**METROPOLITAN GOVERNMENT OF NASHVILLE AND DAVIDSON COUNTY**

**STAFF RECOMMENDATION**  
**1706-1708 Fourth Avenue North**  
**September 17, 2014**

**Application:** Demolition; New construction-infill  
**District:** Salemtown Neighborhood Conservation Zoning Overlay  
**Council District:** 19  
**Map and Parcel Number:** 08205007300  
**Applicant:** Jeremy Leggo  
**Project Lead:** Sean Alexander, sean.alexander@nashville.gov

1706B 4TH AVE  
ELEVATIONS

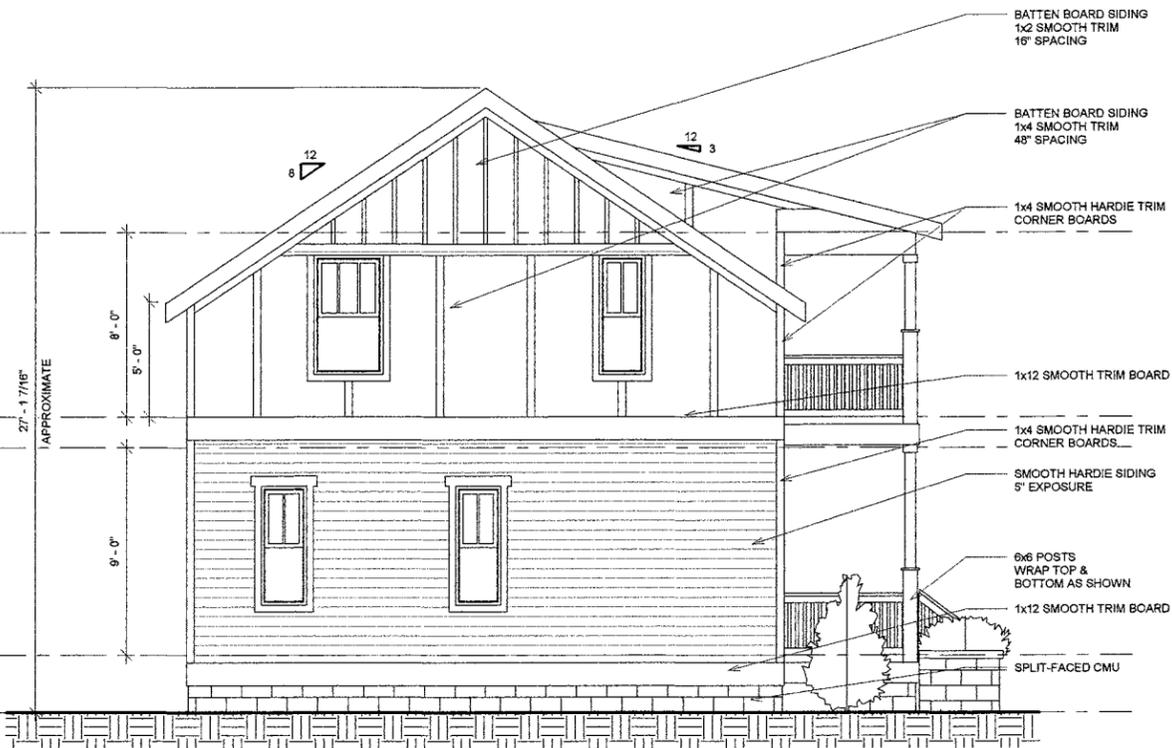
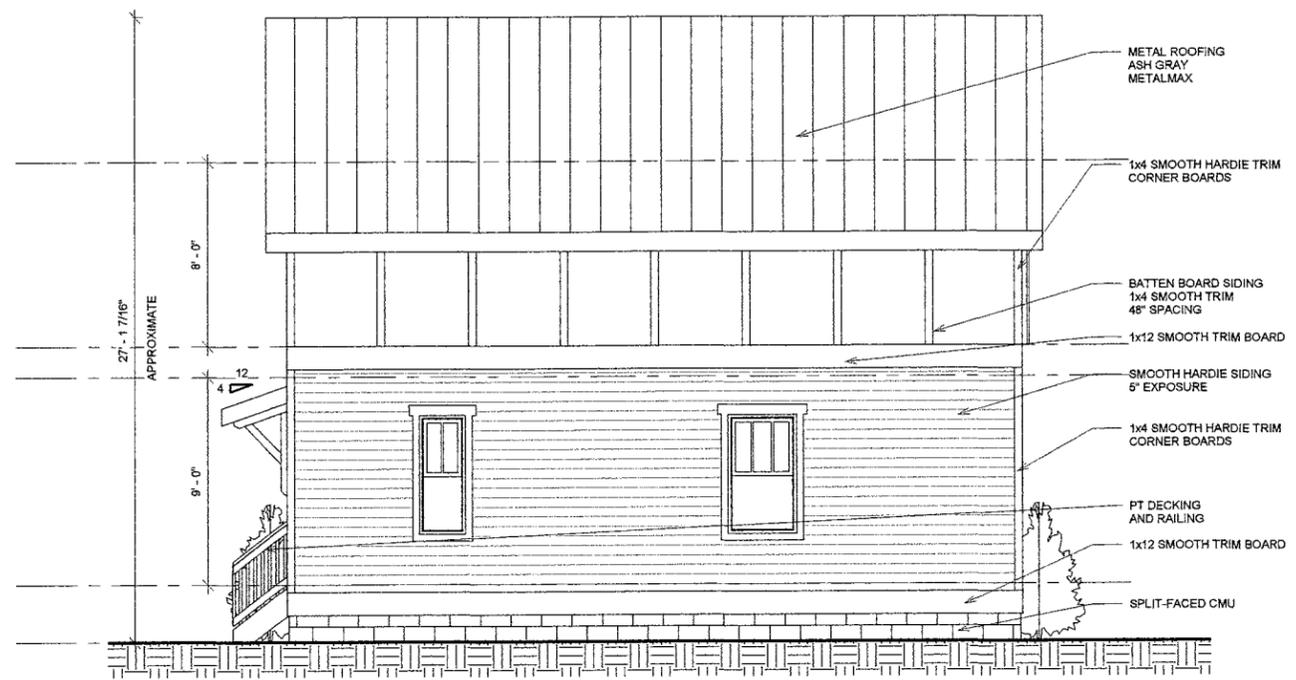
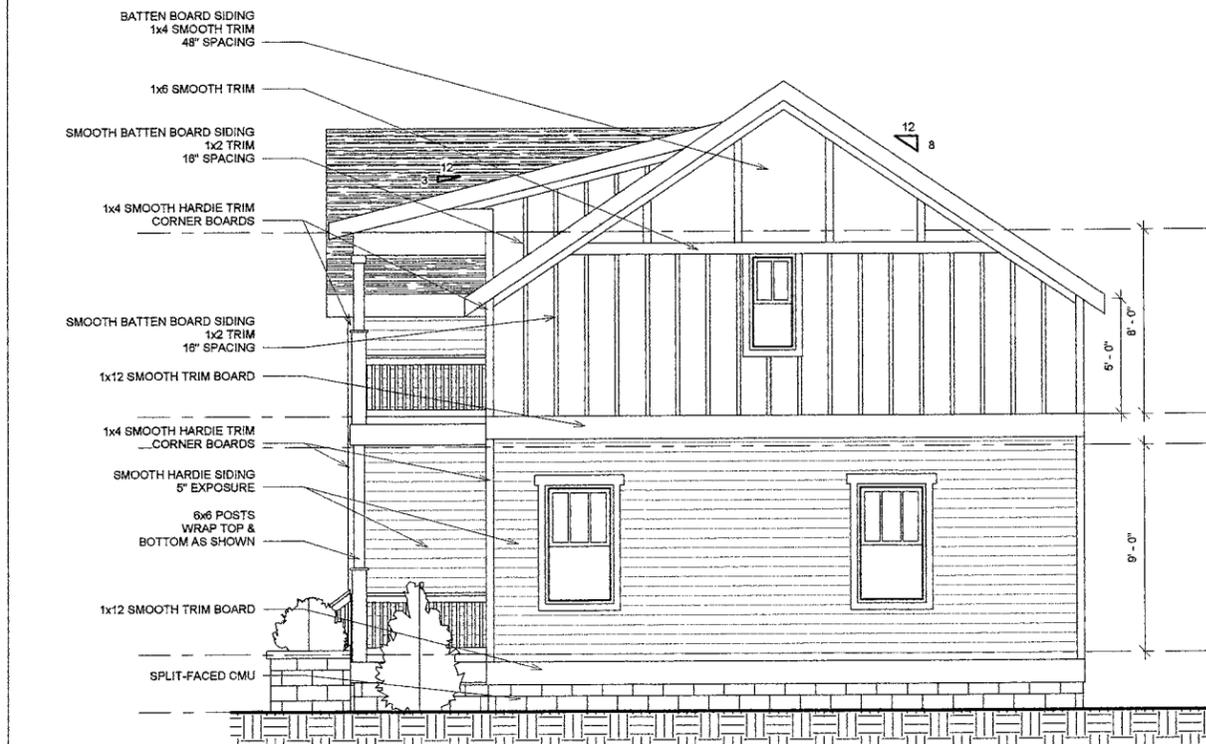
**Analysis and Findings:** The plans for four units at the rear of the development (B and C units) have been revised in the following ways:

The upperstory walls would be shortened from eight feet (8') tall to five foot (5') tall "knee-walls," which brings the eaves from eighteen feet (18') above the finished floor level down fifteen feet (15'). Although this lowers the overall height, it creates proportions that are not seen historically.

Also, the roof pitches would be lowered from 10:12 to 8:12. Together these changes result in the overall heights of the buildings being lowered from thirty-three feet (33') tall down to twenty-seven feet (27') tall from peak to grade.

At the August meeting the Commission discussed the fact that the four units at the rear were not subordinate to the front units, and that the configuration of six "full-sized," two-story, single family homes on two lots was not in keeping with the character of the surrounding area and doesn't allow for a true courtyard, a key component of cottage or cluster developments. Although the B and C buildings would be lowered by six feet (6') with these revisions, Staff finds that because the buildings are still two stories, their footprints are unchanged, and the courtyard is the same size as previously proposed. Because the alterations do not address the Commission's concerns with meeting the design guidelines, staff recommends disapproval.
